# TECHNICAL SERVICE BULLETIN

Bulletin Number: V-17-02  
Model Years: 2010-17

**SUBJECT: 2010-17 Victory Cross Country / Cross Country Tour / Cross Roads /  
Magnum / Hard Ball brake line routing**

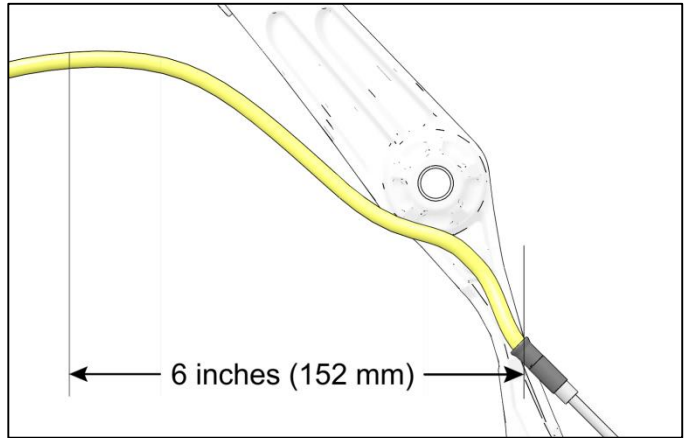
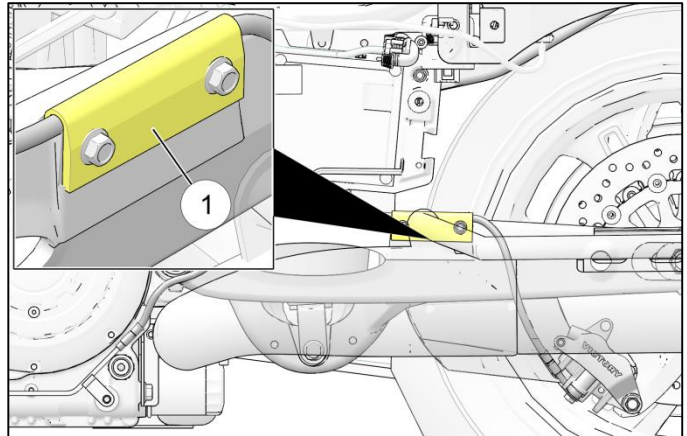
Measure 6 inches rearward from the Brake Line crimp location. Inspect brake line, oil pressure switch and sidestand switch wire (INTL models) for thermal damage.

Measure brake line rearward from Brake crimp location:  
**6 inches (152 mm)**

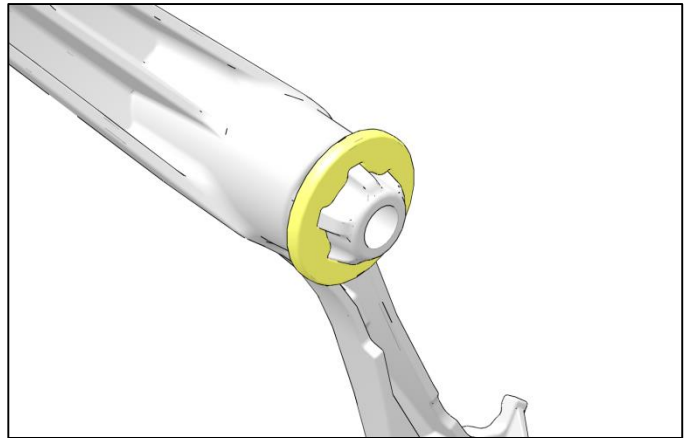
2. **ALL MODELS:**  
Install the swingarm guard over the footrest bracket until fully seated.

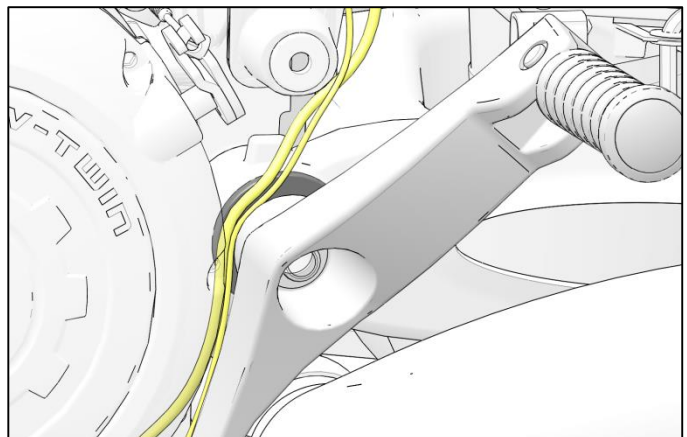
3. **ALL MODELS:**  
**IMPROVED LINE ROUTING**  
Route the brake line and oil pressure switch lines over the footrest as shown. Assemble the footrest over the swingarm pivot until fully seated.  
*\*ABS model routing shown for illustration.*

Verify the brake line and oil pressure switch lines are not pinched between the footrest and swingarm pivot.
